RE: Appeal of Planning Commission Resolution No. 15-66 for MWest – Jarvis RDCS Application No. MC-15-12, 19.5 acres at Butterfield Boulevard and Jarvis Drive, Morgan Hill, CA

MWEST-JARVIS CONTESTED POINT SCORES IN THE 2015 RDCS COMPETITION

EXHIBIT B ILLUSTRATIVES

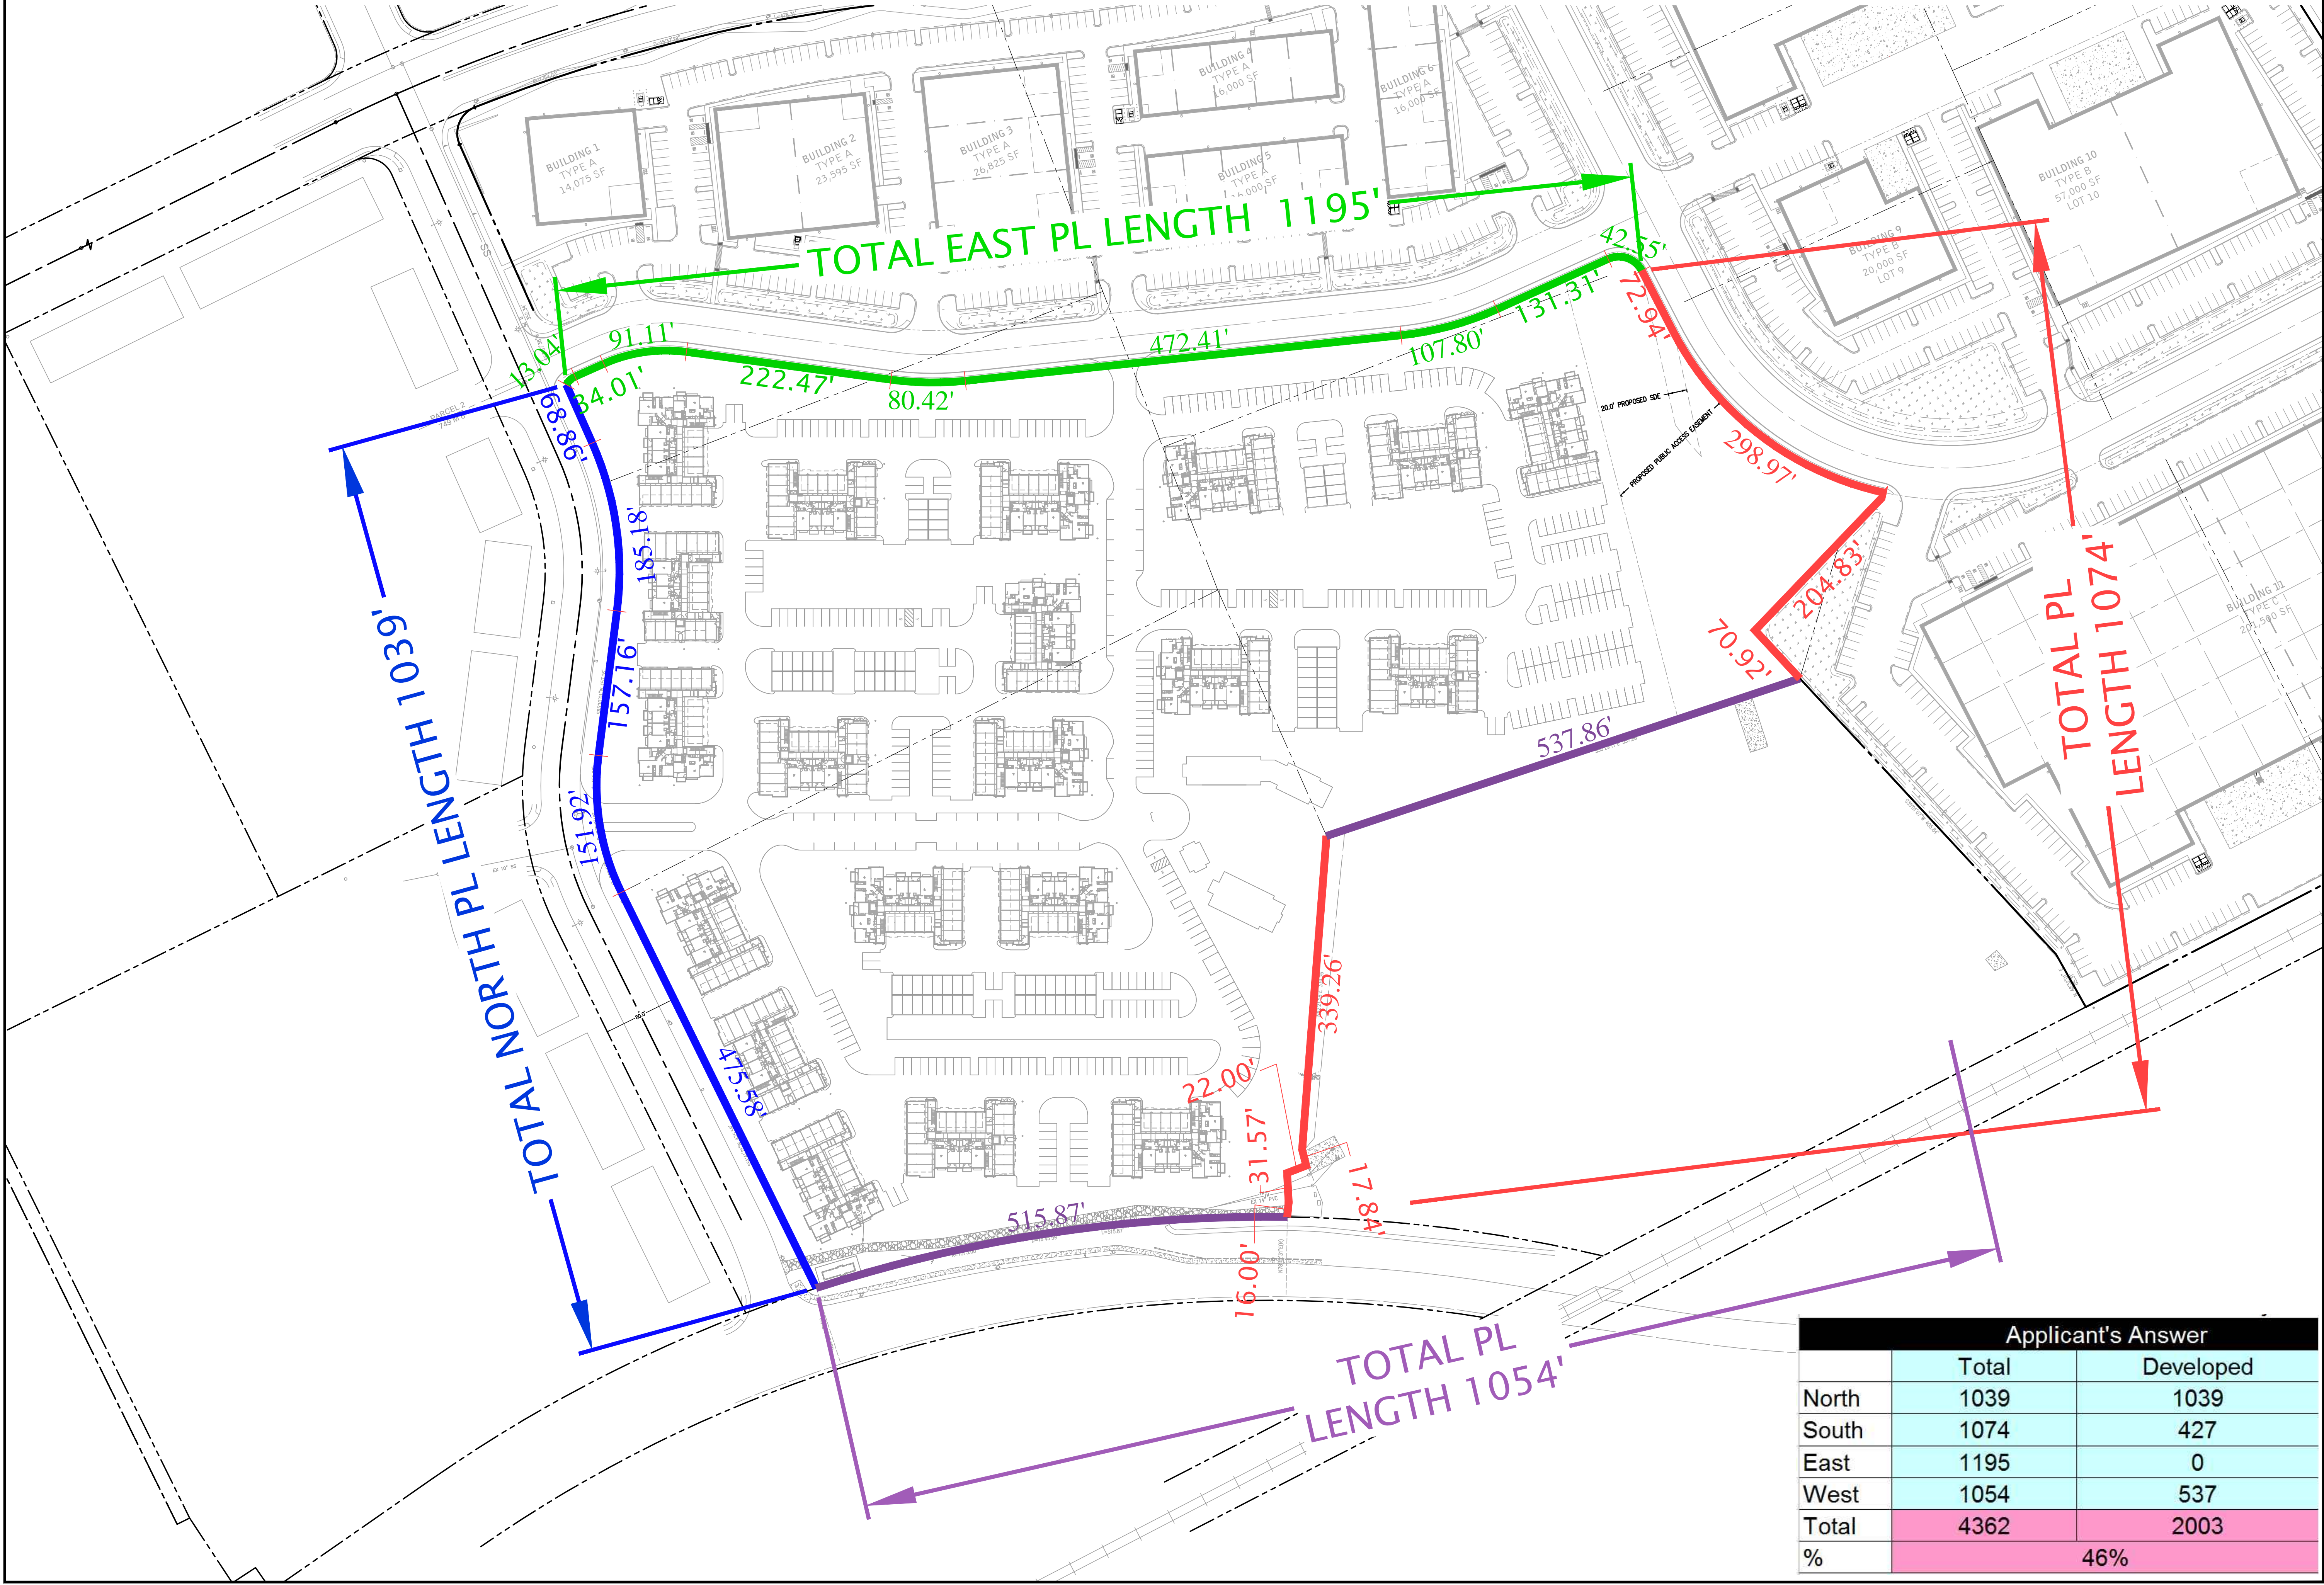
Staff/PC Response: “The City has not agreed to accept this amenity.”

In accordance with the criteria, the project provides accessibility to the basin open space area via two proposed public trails connecting from Jarvis: (1) along the east side of Monterey and continuing around the rim of the basin area, and (2) from Jarvis via a 7 foot wide multi-use path and 40 foot wide landscape buffer located between the industrial and residential and connecting to the Sutter Extension, which will connect to the basin via pathways through the proposed 1.7 acre Central Park. Finally, the project will provide accessibility from Butterfield via new pedestrian paths along the planned Sutter Extension. (Please see illustrative of pedestrian connections in Exhibit B)

ADJACENCY DETERMINATION TABLE - EXHIBIT

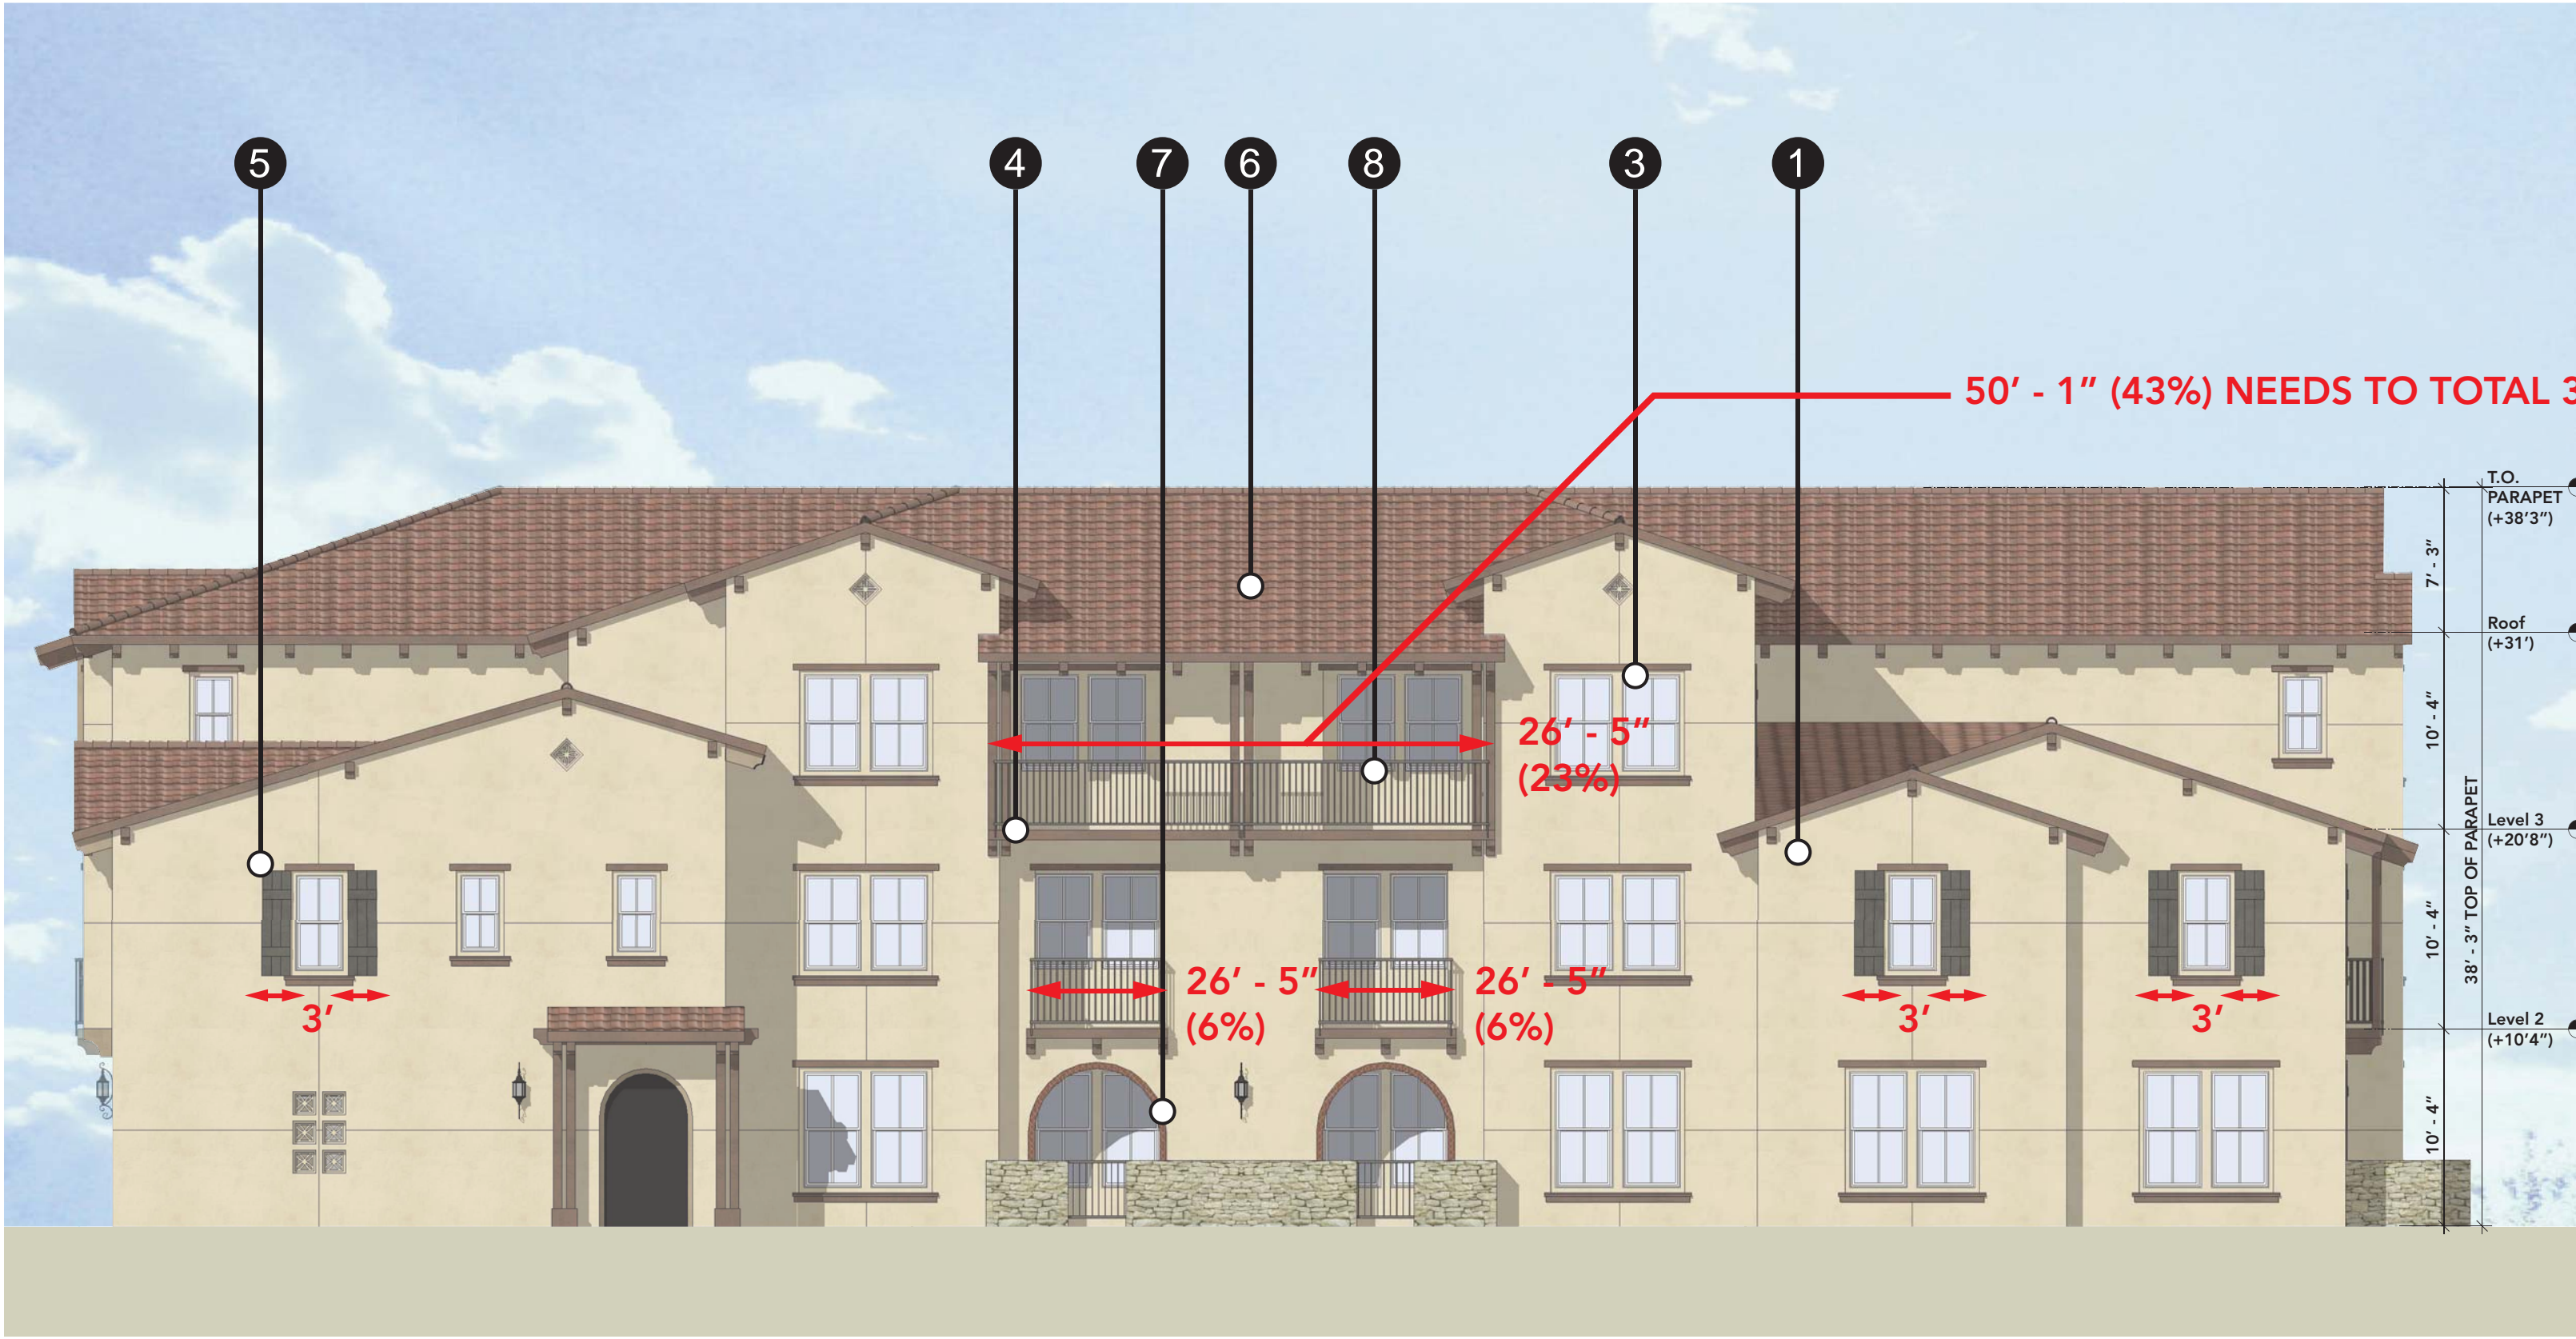
Staff/PC Response: “Properties to the south, east (which includes the applicant’s industrial property) and west are undeveloped.”

Applicant’s Response: We accept Staff’s conclusion that our industrial lands to the east and south do not constitute development under this criteria. Once these lands are approved for development (e.g.; through MWest’s pending application for an industrial DA), the project will be eligible for 2 additional points. However, the assertion we raise here is that two edges of the property (339 LF to the south and 537 LF to the west) are adjacent and contiguous to the City-owned detention pond, which increases the overall developed percentage to 46%, which makes the project eligible for 3 points. (Please see attached Adjacency Exhibit) The City considered the pond contiguous but undeveloped. We contend that the pond should be considered developed or at least substantially developed according to the general plan or zoning given that the land serves the detention/retention needs of the Morgan Hill Ranch Business Park, as well as residential properties north of Jarvis in the Madrone Plaza area. Even if the City elects to convert a portion of the pond to public park and open space use, the land will still be considered “developed” under the criteria. (*“... contiguous property within MH’s UGB committed to an ultimate land use such as a city park, developed school site, or private open space will also be considered as adjacent development.”*) Thus, the project deserves the additional 1 point under this criteria.
